Addendum #4

Date: 2/4/2021
To: YPS Facilities Management; All Bidders
From: LiRo Engineers, Inc.
Subject: YPS 10881 – Saunders HS - HVAC Upgrades Project Addendum #4

**SAUNDERS TRADES
AND TECHNICAL
HIGH SCHOOL HVAC
UPGRADES**

5
H-100A
TYPICAL ASBESTOS CEMENT DUCT CONNECTION TO
UNIT VENTILATORS
Not To Scale

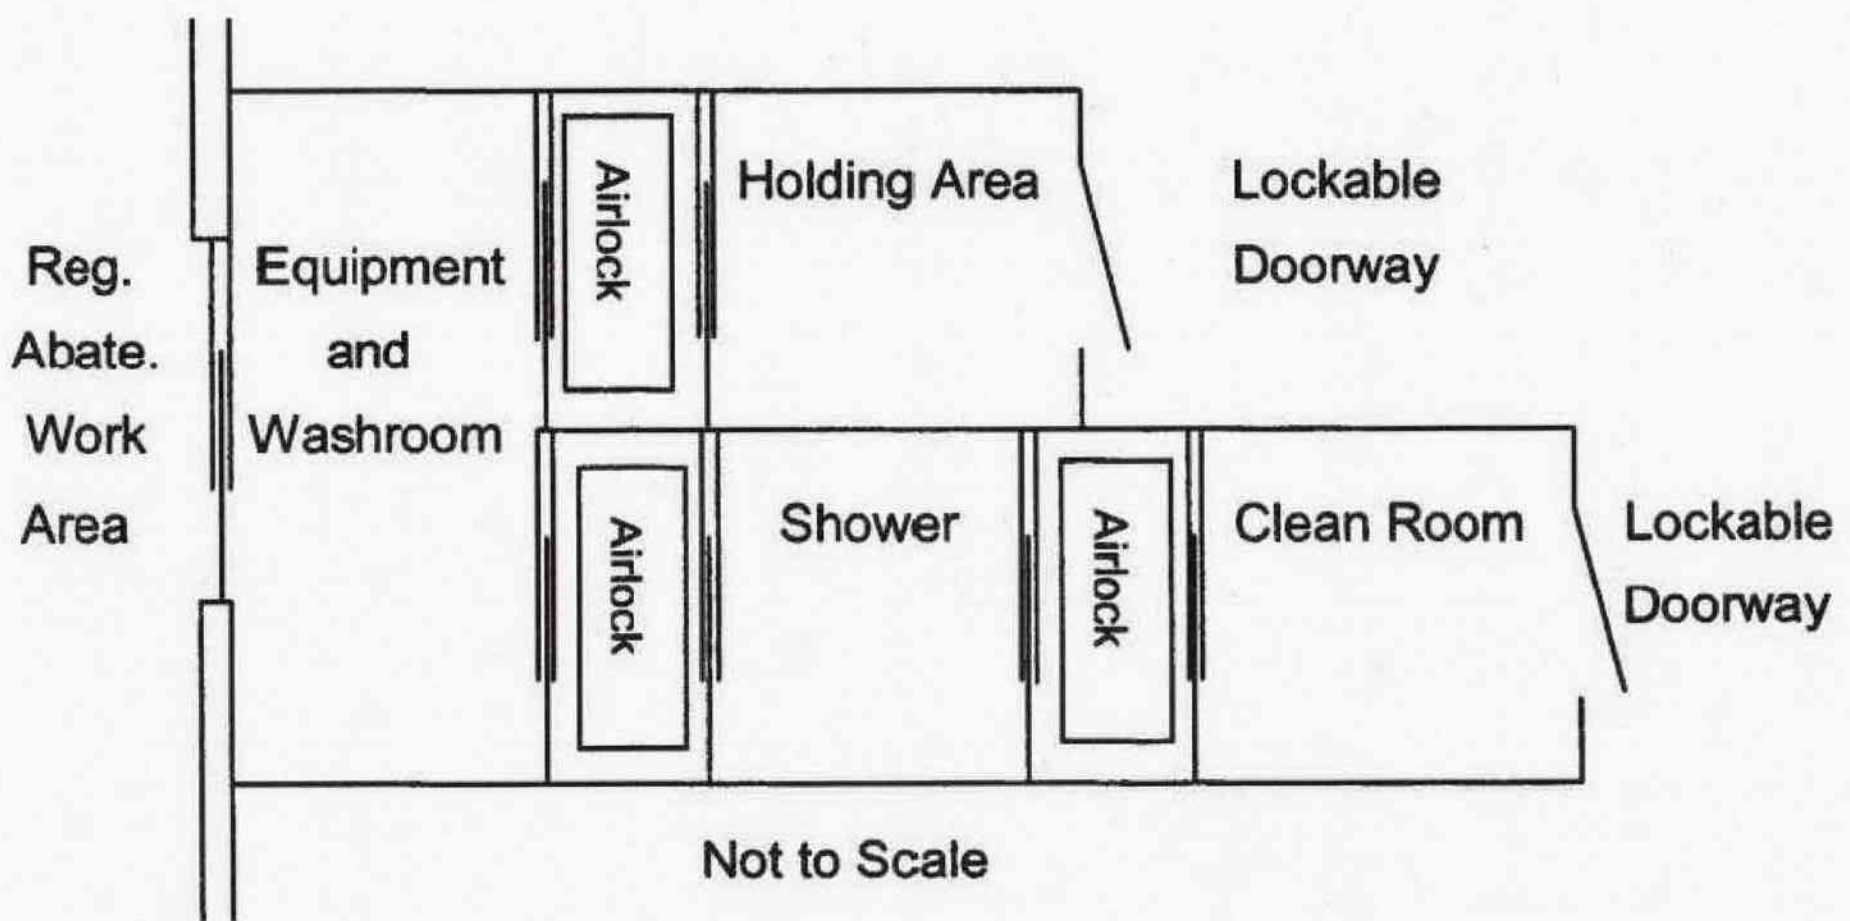
10. For Work Areas 4,5,6 & 7 (H-102), the asbestos cement ducts leading to the unit ventilators shall also be capped & sealed air tight at the subgrade intakes.

FIGURE 1:
MECHANICAL ROOM EXHAUST FAN
EF-10A

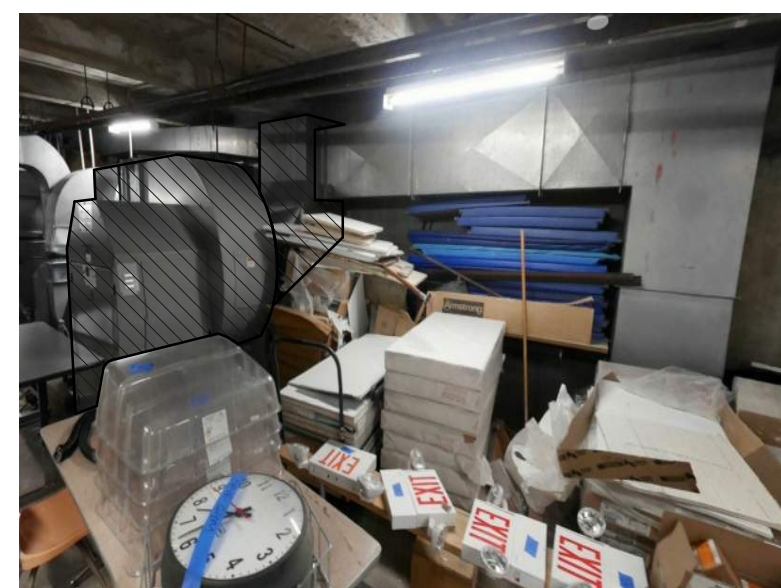
- DISCONNECT 24x32 EXHAUST FAN CONNECTION FROM 24x24 RETURN MAIN AND PATCH DUCT TO MAINTAIN INTEGRITY OF RETURN DUCT MAIN. EF-10A AND ASSOCIATED 24x32 DUCT TO BE DEMOLISHED. (SEE FIGURE 1)

FIGURE 4:
MER ROOM DUCT TRANSITION FROM
EC-6

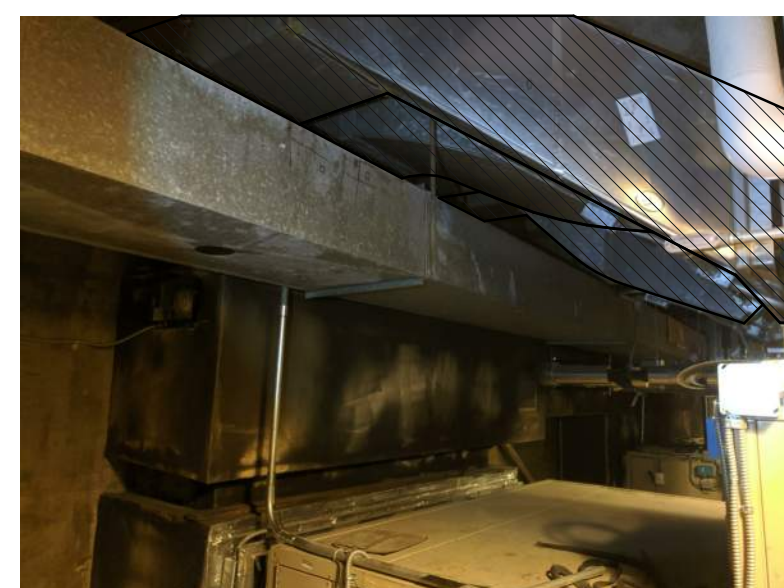
- DEMOLISH SUPPLY AND RETURN DUCTWORK FROM UNIT EC-6 UP TO 6 INCHES FROM WHERE TRANSITION TO TRANSITE DUCT OCCURS. REMAINDER TO BE REMOVED AND SEALED BY ABATEMENT CONTRACTOR. (SEE FIGURE 3 & 4)
